Validating C2M VEC and VEO Limits

IEEE 802.3ck Task Force

April 21, 2021

❑ Addressing D2.0 comments 34, 41, 42, 46, and 48.

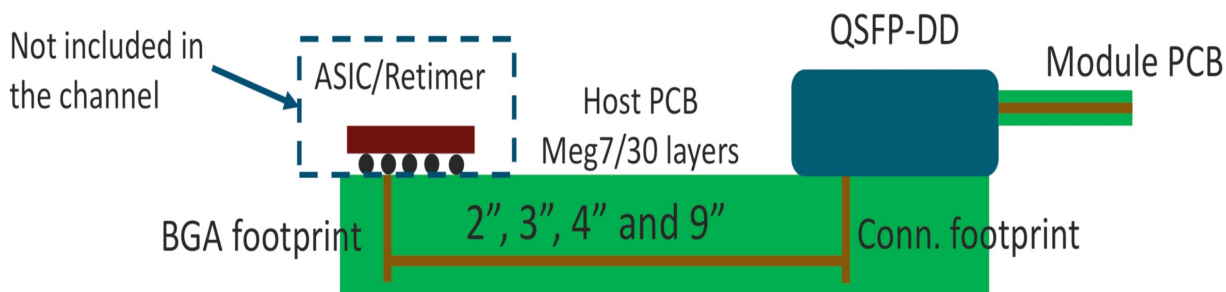
❑ COM analysis investigates impact of $t_s = \pm 50$ mUI rectangular window on established VEO/VEC limits of D1.3 draft

- The intention was to only adjust the TP1a/TP4 limits due to $t_s = \pm 50$ mUI rectangular window
- But D2.0 VEO/VEC limits at TP1a have been tighten compare to D1.3 without rectangular window for the host and relaxed for the module
- Tightening the VEO/VEC limits results in some of Lim TP1a channels failing that previously passed

TP1a Eyes for 2" and 9" Lim Channels

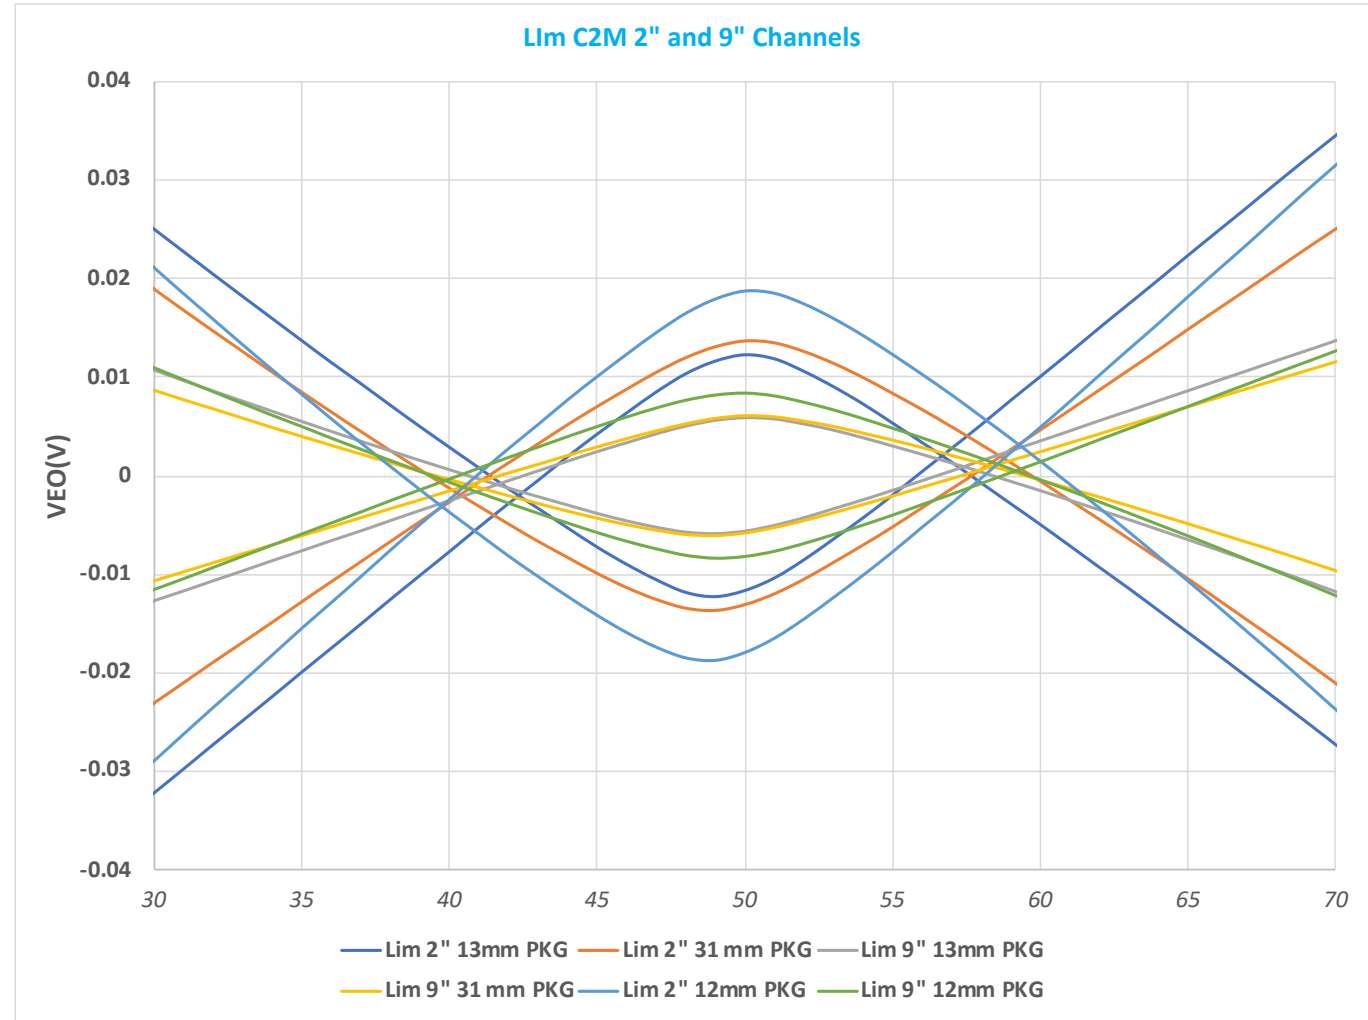
□ The eye show the impact of sampling window on the VEO and associated VEC

- Given the eye shape there could be as much as 5 dB of VEC penalty due to +/- 50 mUI window
- The same eye with the window may have ½ the eye opening.

M2C Short and Long Channels

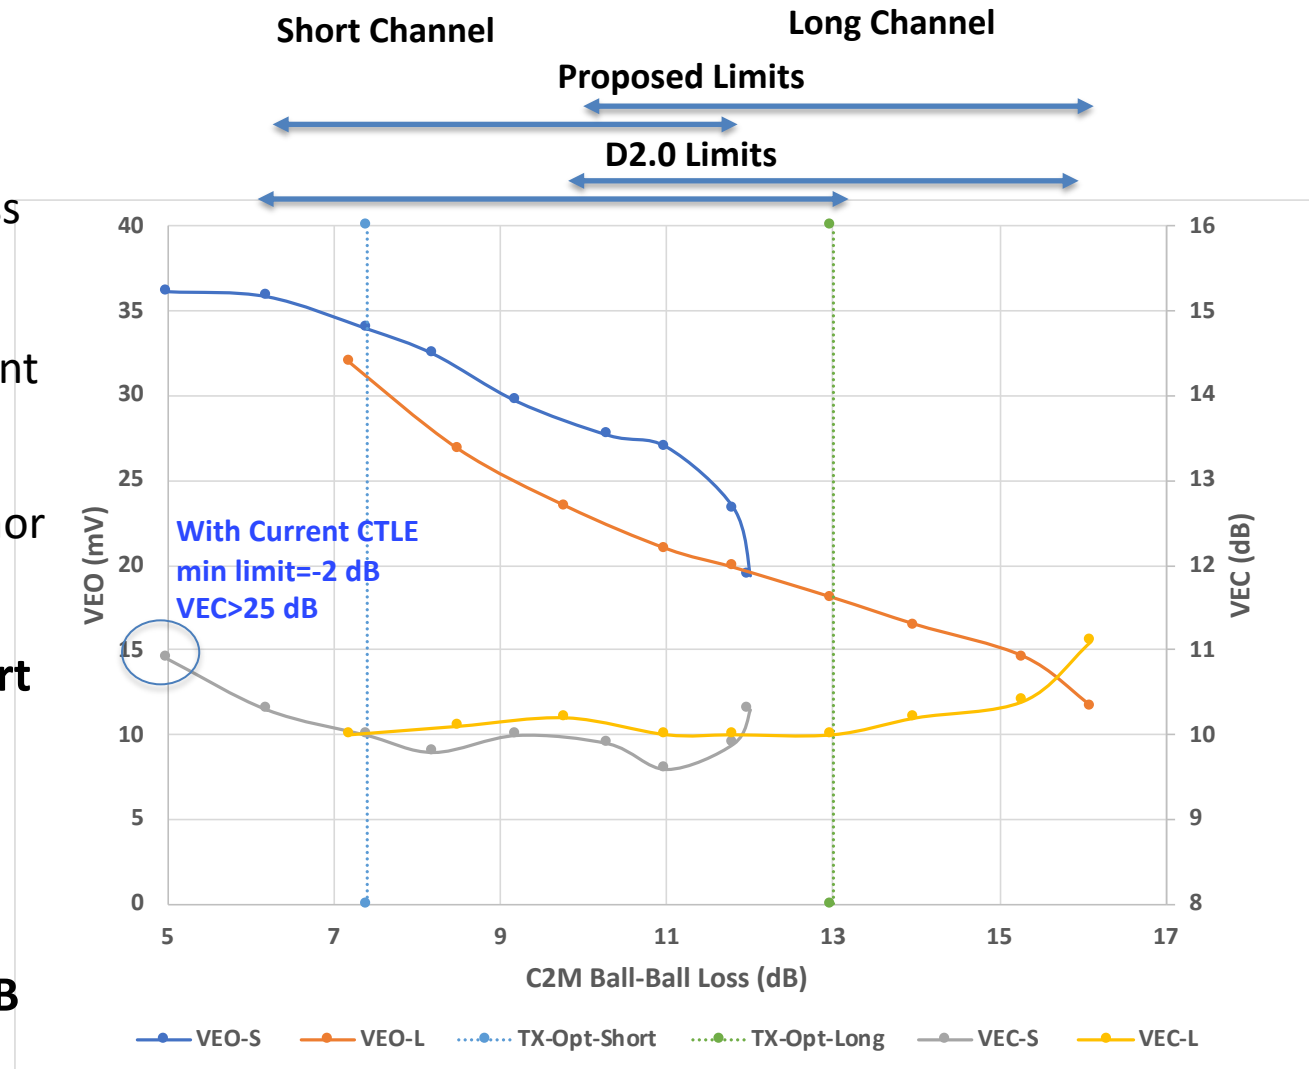
Current D2.0 definition of TP4 short and long

- Short 0 – 160 mm (6.6 dB) + MTF Loss
- Long 80 mm (3.1 dB) – 244.7 mm (9.6 dB) + MTF Loss
 - 9.6 dB + 6.6 dB MTF loss exceed max 16 dB
 - 244.7 mm should be reduced to 239.7 mm (9.4 dB)
- Short channel max loss up to 13.2 results in significant VEC/VEO degrading
 - Propose to reduce short channel max loss to 12 dB
- Not clear if MTF variations should be accounted or nor with current procedure explicitly specifying added trace

Proposed new limit for TP4 short/long adjusting short max loss and accounting for MTF loss

- Assumes MTF loss of 6.6 dB
 - Short range will be from 6.6 – 11.8 dB (0 – 132.6 mm)
 - Long range will be from 9.7 – 16 dB (80 – 239.7 mm)

If one allow short range to go to as low as 5 dB VEC > 25 dB but this issue is avoided if one adjust for 1.6 dB MTF loss difference otherwise gDC need to be reduced from -2 dB to -1 dB.
